From: Fay <fay.patterson@bisa.asn.au> **Sent:** Friday, 14 June 2019 10:51 AM **To:** 'Ian Radbone' <ian@bisa.asn.au> **Cc:** Chris Bentick <cbentick@charlessturt.sa.gov.au>; portadbug@gmail.com; katie.gilfillan@bisa.asn.au **Subject:** RE: Outer Harbor Greenway Safety Improvement - Intersection of Belmore Terrace and David Terrace, Woodville Park

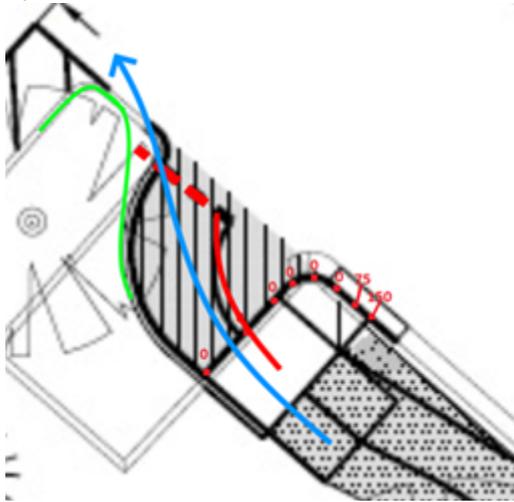
The kerb ramp is transitioned to road level at the existing edge of kerb, on the eastern side of an existing car park space. This means that the design turn path for cyclists coming off the path into the road or vice versa is limited to the width of the car space – which does seem wider than a normal space, at around 3m. This means cyclists travelling to/from the path have to do a fairly tight turn to get on/off the path. In truth, they'd be likely to use the entire path width to give a smoother travel path, but this wouldn't be an option if they encounter a cyclist coming the other way.

The grades at the wing should help the cyclist on the inside curve i.e. City-bound, which is good. (I've shown paths as if they're following the nominal edge of path.) However, the travel path for the other direction is still a bit tight.

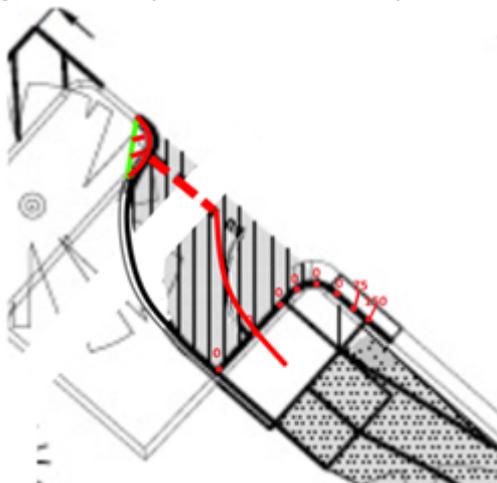
- 1) Cut off the corner of the kerb where it's formed around the existing tree protection area.

This would allow a smoother travel path for the cyclist, including eliminating any risk of clipping the corner, as may happen when they're a bit distracted – like, by looking for cars turning into Belmore

Tce from the southern side of David Tce, which means a head check to see what's behind them. Reflect the change through the line-marking – and, dare I say, line-marking that reflects the actual expected use of space in both directions.

2) If there's a feeling that this would introduce cyclists into Belmore Tce a bit too fast, too close to the rear of a parked car (the design includes some line-marking to encourage a car to position away from the ramp, but...), or encourage them to exit without doing the important looking behind, an option might be to shift the entire ramp/ transition east by 0.5-1.0m i.e. don't set up its parameters according to the kerb of the car space, but the needs of the cyclists. This should similarly allow for a smoother path of travel but set the manoeuvre space back ever so slightly from the actual entry to Belmore Tce, giving an alignment when they enter which is more conducive to checking and yielding to traffic. Though TBH, I'd still cut back the corner a little bit, even if it means line-marking it back in – guess I'm just the sort of person who'd clip the kerb!

We have considered the recommended amendments and have shaved off some of the corner to reduce the risk of clipping the kerb (I should also point out that the proposed edge kerb is median kerb, not upright, so it should be more sympathetic to inadvertent impacts).

We are reluctant to amend line marking to further reduce the angle of entry because:

- 1 Cyclists entering Belmore Terrace are being sent into a 3.2 travel lane, not a designated cycle lane and, in our view, should be encouraged to approach the road 'squarely', in a position where they can check over their right shoulder for traffic in Belmore Terrace. Reducing the angle of entry to the road reduces the ability to observe northwest-bound traffic in Belmore Terrace.
- 2 In our view, cyclists entering the path from Belmore Terrace shouldn't be encouraged to cut the corner and travel against the flow of traffic to enter the ramp.

It really is a matter of striking the balance between safety and convenience. When we create conditions for fast and convenient entry and exit to the path, we also create conditions by which path users are less able and likely to adequately respond should there be conflict with motor vehicles in Belmore Terrace. We regard the ultimate design as maintaining that balance.

We have decided to keep the exit ramp where originally proposed. At 3.2m wide, the parking bay which will be used for the exit is regarded as sufficiently wide. Shifting by ramps to the southeast by 1.0m will be relatively costly with only marginal benefit.

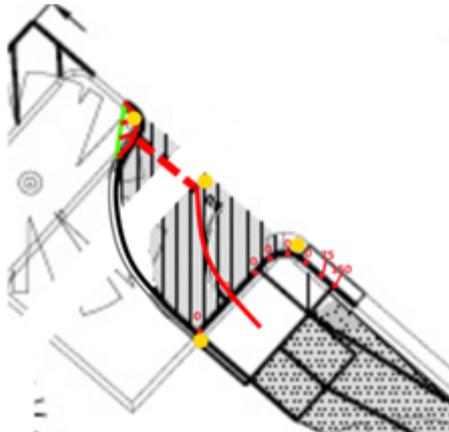
As a thought, the lighting probably isn't the best out there. I'd

suggest adding some solar LED cateyes on either side of the entry point and in the middle, to give some guidance at night. And maybe one at the top of the kerb after the manoeuvre area. As per yellow blobs below. Would you believe, they've now got holographic ones which are installed flush with the surface but throw out light as if they were raised? That would certainly ensure they don't present a path hazard! TBH, the dome-shaped ones like the ones we had trialled on Linear Path seem fine and I'm sure these are cheaper. Hmm, guess they can't be specified as RRPMS if they're not raised or retro-reflective...

And/or they could try glow-in-the-dark paint on the kerb and line-marking, but I'd think this would be a maintenance issue – the solar cateyes are set-and-forget for about 10 years. You can buy a can of glow-in-the-dark spray paint at Bunnings, I believe, so they wouldn't have to be at the mercy of contractors to supply/install it – at least on raised kerbs as the stuff at Bunnings isn't suitable for line-marking. It is also possible just to buy the material and mix it with an industrial varnish and coat it over the top of paint, which is apparently what the contractors are now doing since not mixing it with paint allows the glow to work better.

We will be upgrading the lighting in the area next year, so lighting near the ramps will be significantly improved.
